Catawba Nuclear Station, Units 1 and 2, Request for Additional Information
Regarding Expedited Seismic Evaluation Process Report

Enclosure 1- Catawba Nuclear Station Response to the NRC Request for Additional Information (RAI) Regarding Expedited Seismic Evaluation Process Report

Enclosure 1
Duke Energy Response to Questions
Related to the Catawba
Expedited Seismic Evaluation Process (ESEP) Report
Catawba Nuclear Station, Units 1 and 2
Docket Numbers 50-413 and 50-414
Renewed License Numbers NPF-35 and NPF-52

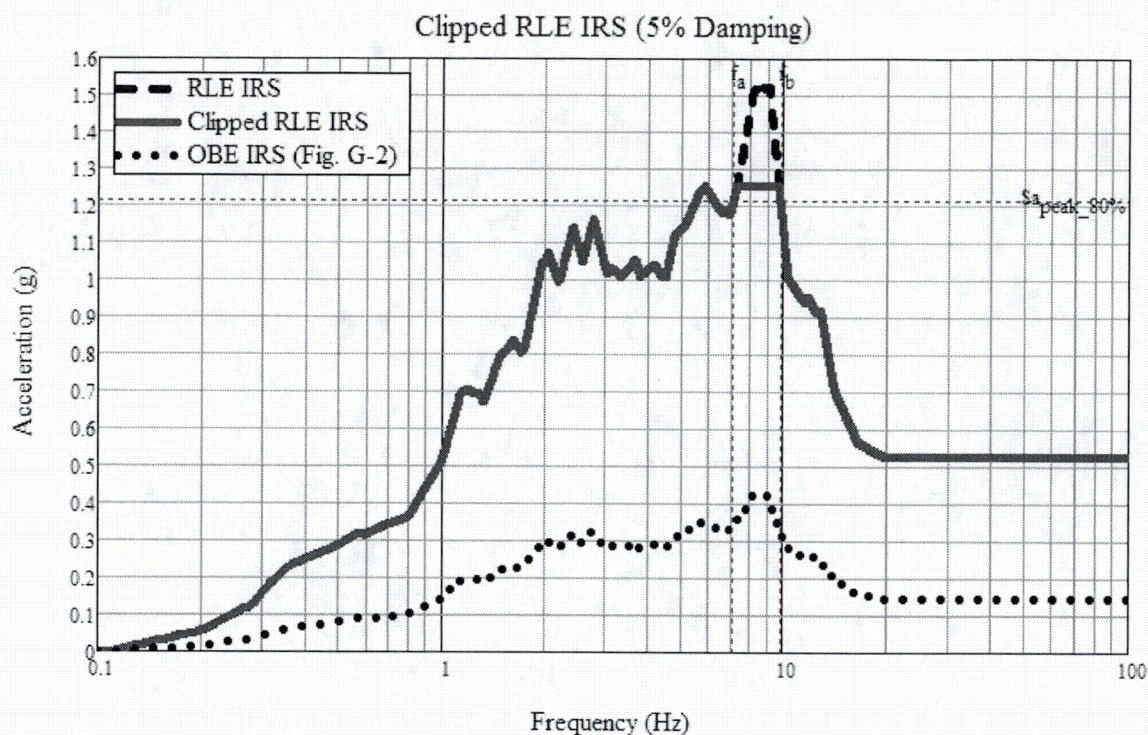
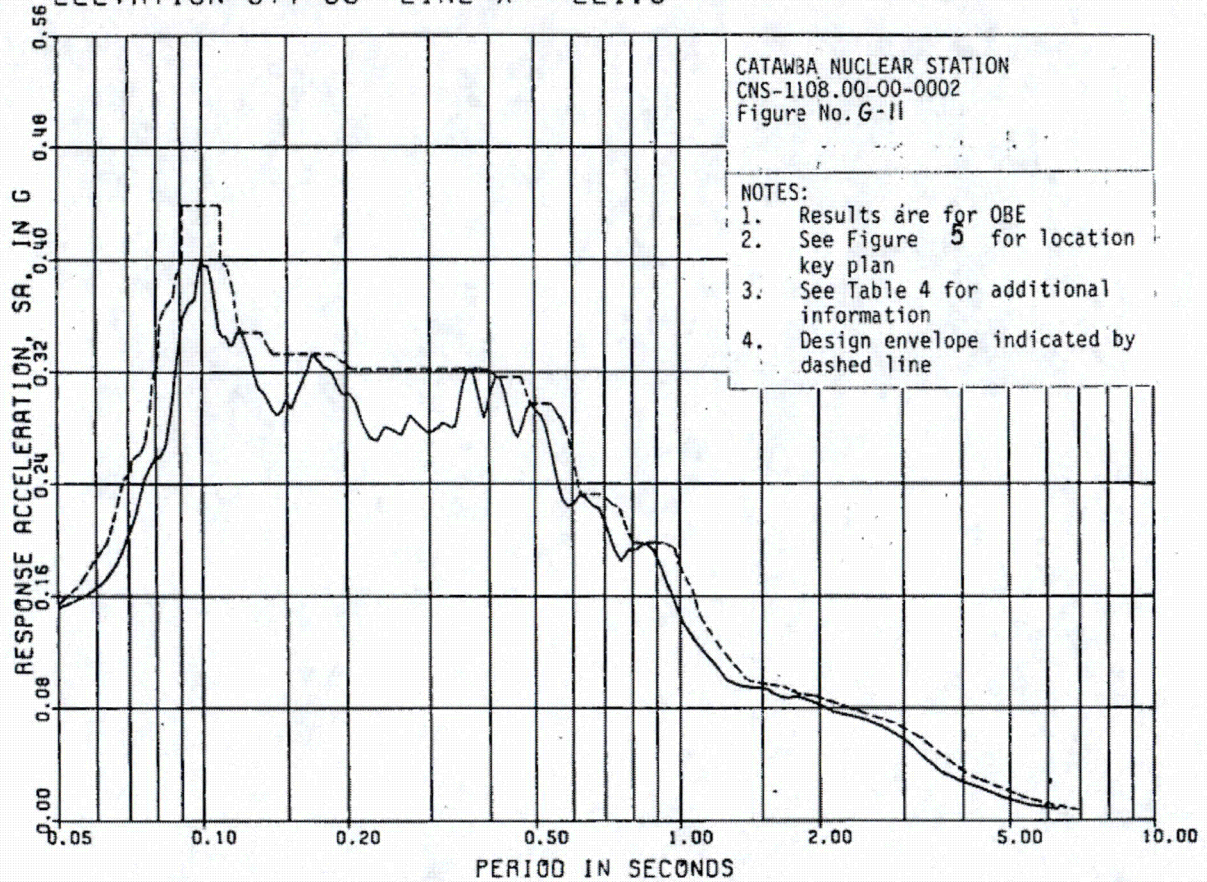
- (2) The CNS ESEP submittal also states that for equipment in the Auxiliary Building, new floor response spectra were generated for the RLE per EPRI NP-6359 and that the SSE ISRS were amplified by a factor of 1.91 (RLGM scale factor) throughout the frequency range and were then clipped (per EPRI 1019200), using the methodology in EPRI NP-6041-SL. Clarify and provide the technical basis to determine whether raw, narrow-band ISRS for the Auxiliary Building were generated, followed by clipping and averaging, and whether any shifting was introduced as recommended in EPRI NP-6041-SLR1. Additionally, provide the range of calculated clipping factors, the reference for the equation used, and an example showing representative raw ISRS and the corresponding clipped ISRS.

The ESEP peak clipping followed the methodology in Appendix Q of EPRI NP-6041-SL (specifically Equations Q-2, Q-4, and Q-6). The calculated clipping factors ranged between 0.55 and 1.0. If the calculated clipping factor would reduce the primary peak to less than an adjacent peak, the reduction was limited to the value of the second peak. None of the clipping factors were less than 0.55.

An example of clipping is shown below. It should be noted that peak-clipped ISRS were not used for anchorage evaluations.

The RLGM spectral accelerations are 1.91 times the SSE, which are 1.875 times the Operating Basis Earthquake (OBE) spectral accelerations in the figure. Thus, the RLGM peak spectral acceleration is 3.58 times the peak spectral acceleration from the figure, or 1.52g. The clipping factor is computed using Equations Q-2 and Q-6 of EPRI NP-6041-SL. The calculations and resulting peak-clipped spectrum are shown below. Note that "RLE" as used in the calculation refers to the RLGM.

Note that manual clipping was performed in order to prevent the clipped peak from falling below the secondary peak, which is relatively wide at 80% of its peak.
